SERVICE BULLETIN

No. 273

Subject: Inspection of Turbocharger Tailpipe Clearance to Firewall
(See attached AiResearch Service Bulletin No. 14.1.8)

Models Affected: PA-23-250 and PA-E23-250 Aztecs (Turbocharged)

FIGURE I

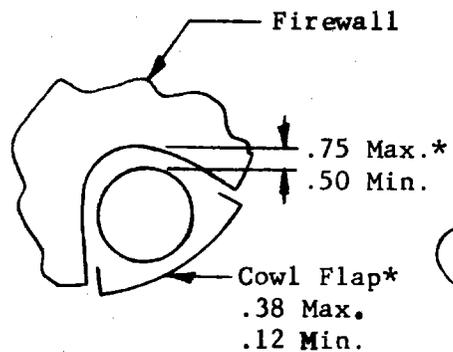
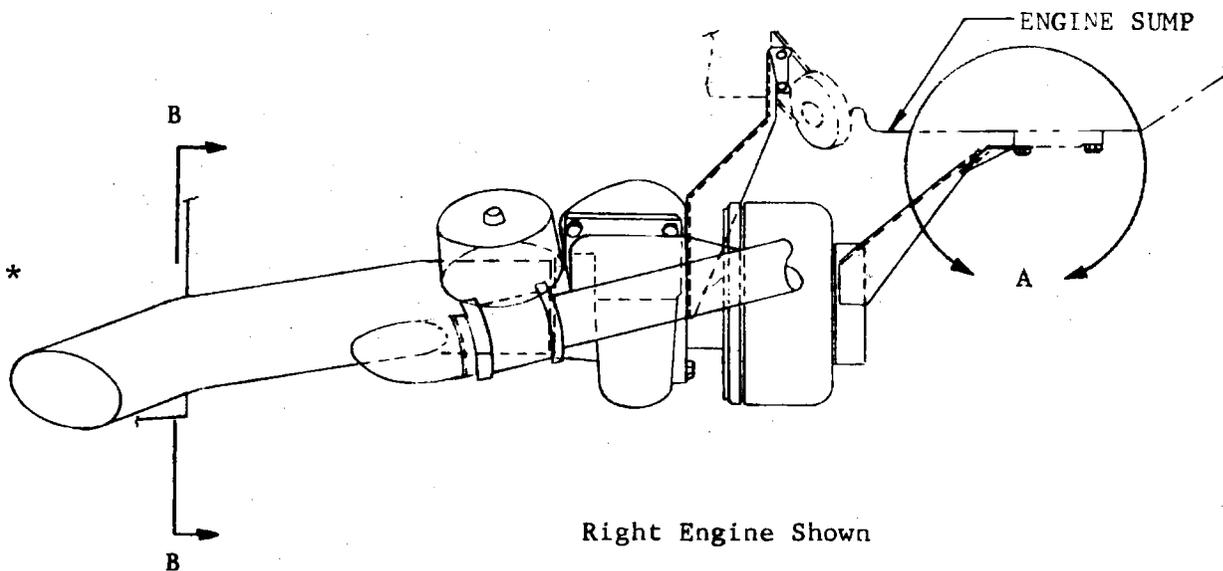
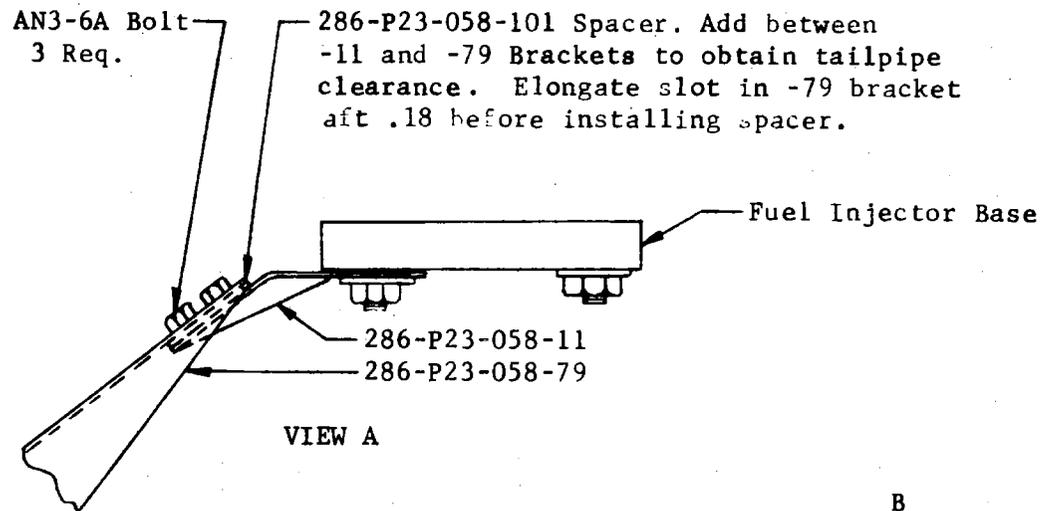
Inspect both the left and right engine tailpipes for sufficient clearance to the firewall. Cowl flap clearance should not be less than .12" or more than .38". The tailpipe should be generally centered in the nacelle cutout and should clear the structure by not less than .50" or more than .75".

1. Remove the cowl scoop and lower cowl(s).
2. Adjust turbocharger to get desired tailpipe clearance as outlined in the AiResearch Maintenance Manual (Ref. Pg. 19). (As revised)
3. If the desired clearance cannot be obtained, install spacer(s) P/N 286-P23-058-101; between the 286-P23-058-11 and -79 brackets to obtain a .75" clearance. See Fig. I on Page 2.
4. After installing the cowling adjust the aft cowl flap to clear the tailpipe by .12 min. and .38 max.

NOTE: Check clearance after running the engines to ensure that the tail pipe is not rubbing the firewall, and that the .50 min. and .75 max. clearance is maintained.
